# Groundwater Transfer Review Summary Form

Transfer/PA # T- 13611

Application: T-13611

Applicant Name: Boersma Family LLC

### Area Hydrographs

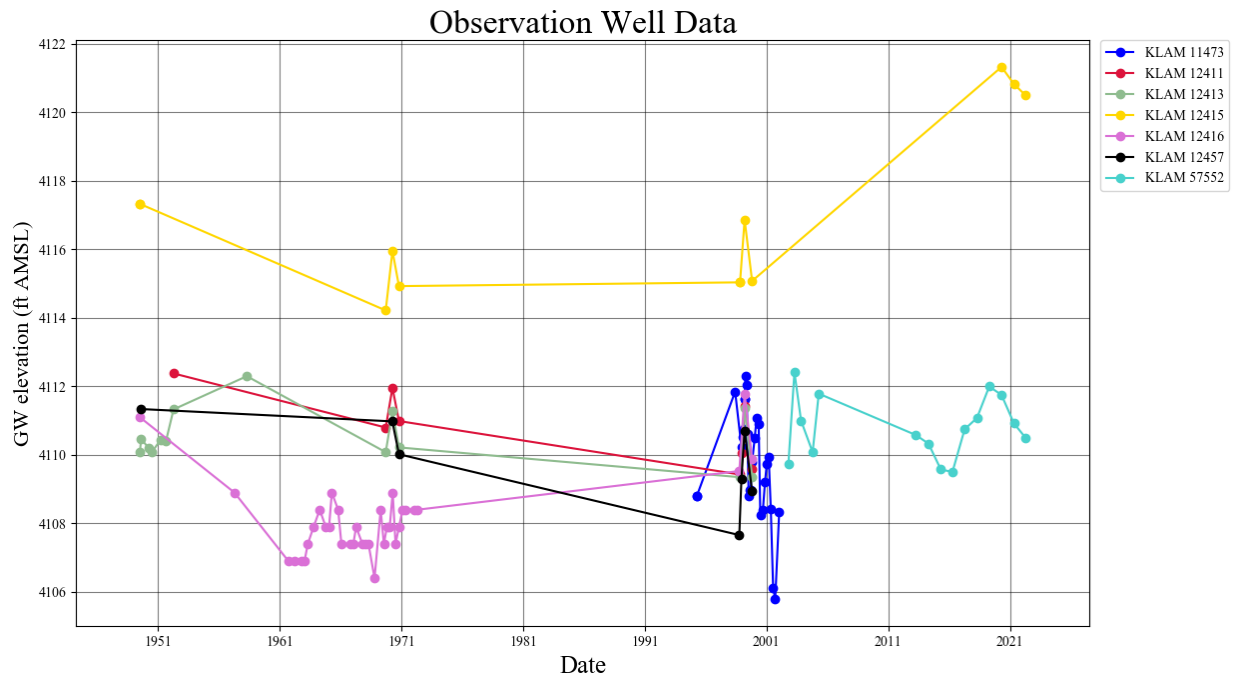
☒ Yes   ☐ No   Comments: Despite the various completion depths of the wells affected by this transfer, the wells all appear to source water from the Tertiary volcanic rock and sediment aquifer and exhibit similar static water level elevations. Other wells in the area drilled to various depths also have similar static water level elevations suggesting a vertically-continuous aquifer system.
  3. a) Is there more than one source developed under the right (e.g., basalt and alluvium)?

## Transfer Review Map

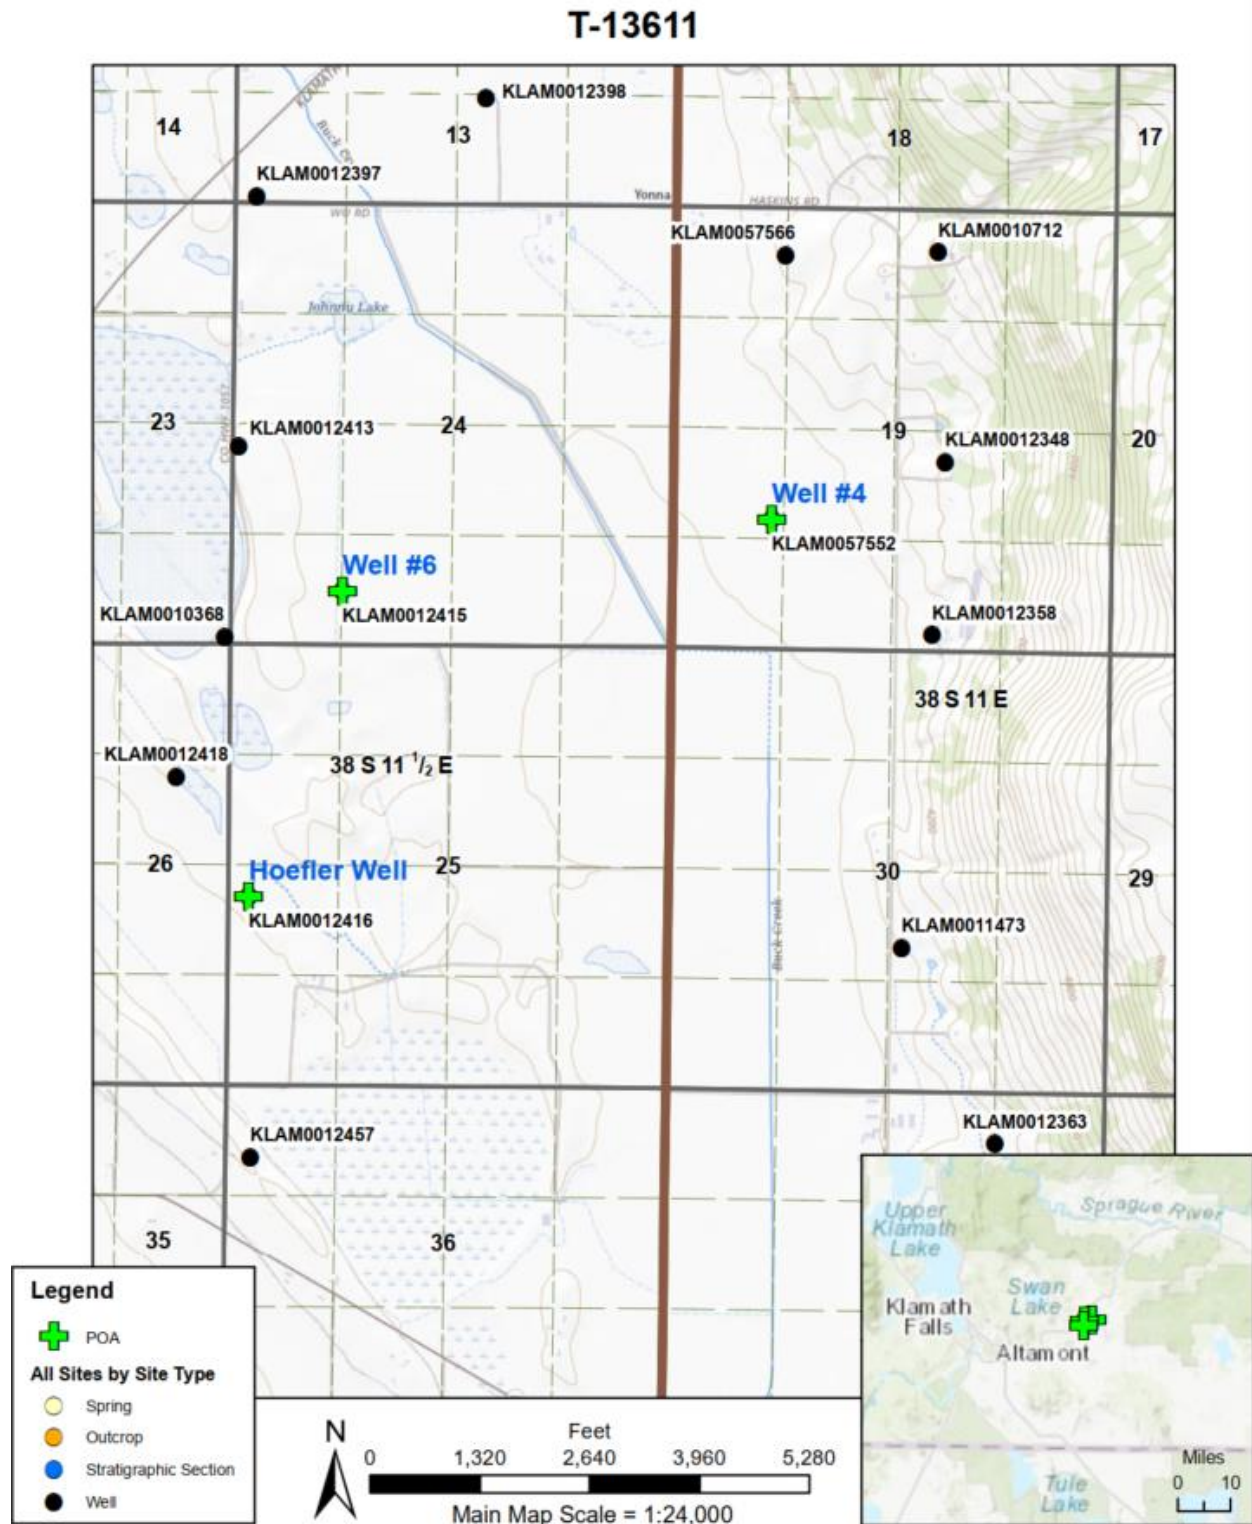
1. Basic description of the changes proposed in this transfer: **NOTE: The application forms identify "Well #4" as KLAM 59552, however, this well log does not match the provided T/R-S or mapped location of "Well #4". OWRD's GWIS correlates the applicant's mapped location of "Well #4" as KLAM 57552. Given the closeness of the Well Report ID number, it is likely that a scrivener's error occurred when filling out the transfer application. This groundwater transfer review assumes the correct Well Report ID for "Well #4" is KLAM 57552.**

☐ Yes   ☒ No   Comments: While proposed POA Well #4 is closer to Buck Creek than authorized POA Well #6, however, the Hoefler Well is further from Buck Creek than Well #6 is. Considering that more use will be transferred to the Hoefler well than to Well #4, it is unlikely that this transfer will result in an increase in interference with Buck Creek.
